CITY OF ST. AUGUSTINE HISTORIC ARCHITECTURAL REVIEW BOARD

A G E N D A - AMENDED*

THURSDAY, APRIL 15, 2021 - 1:00 PM

Project number: 2021-0047 Project Address: 75 King Street
Reviewed by: Julie Courtney Date: 03.24.21

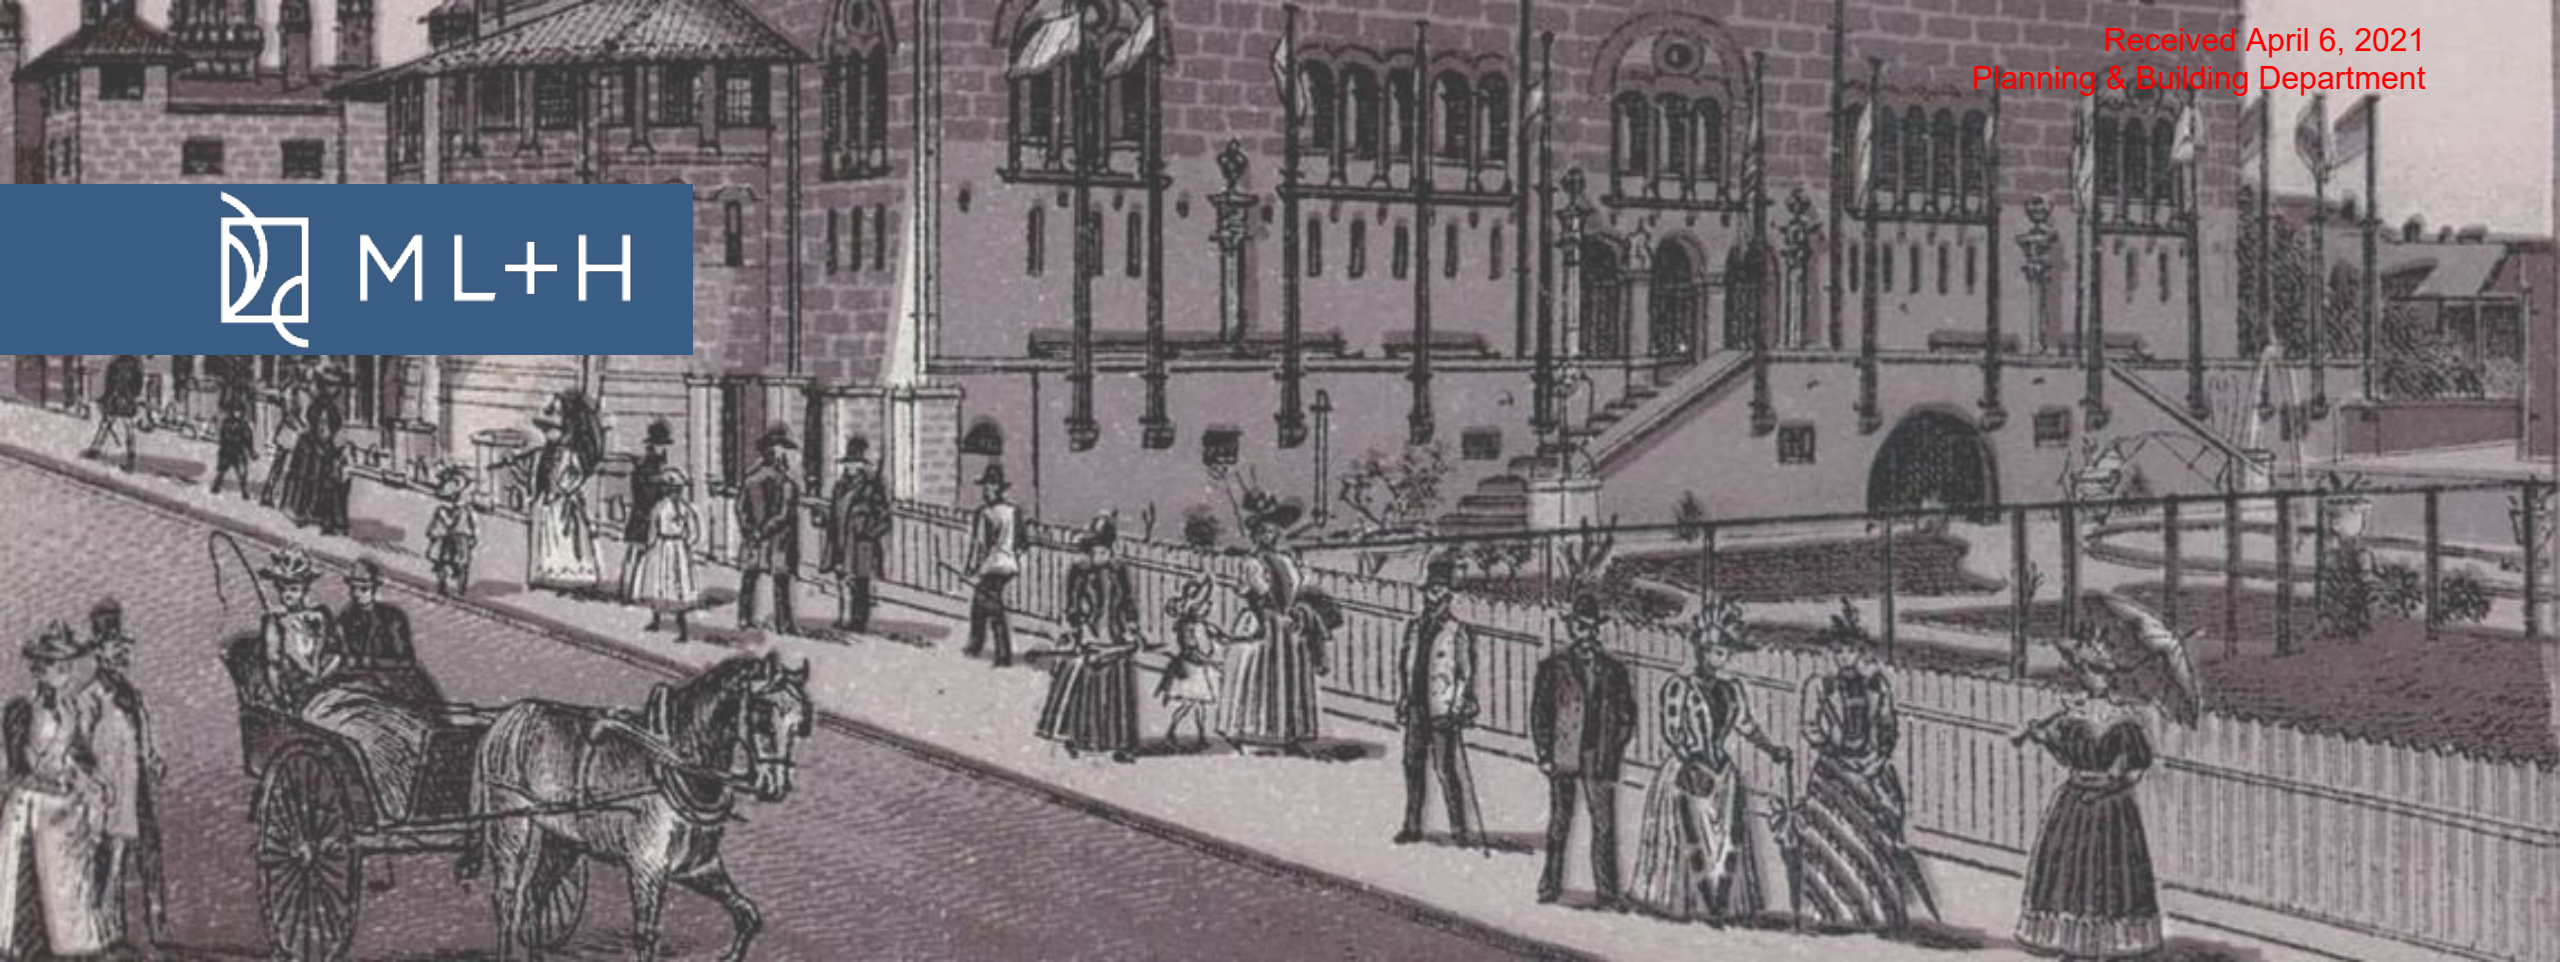
Need detailed on any proposed alterations to the fountain including modern tile, updated fountain spring, etc.
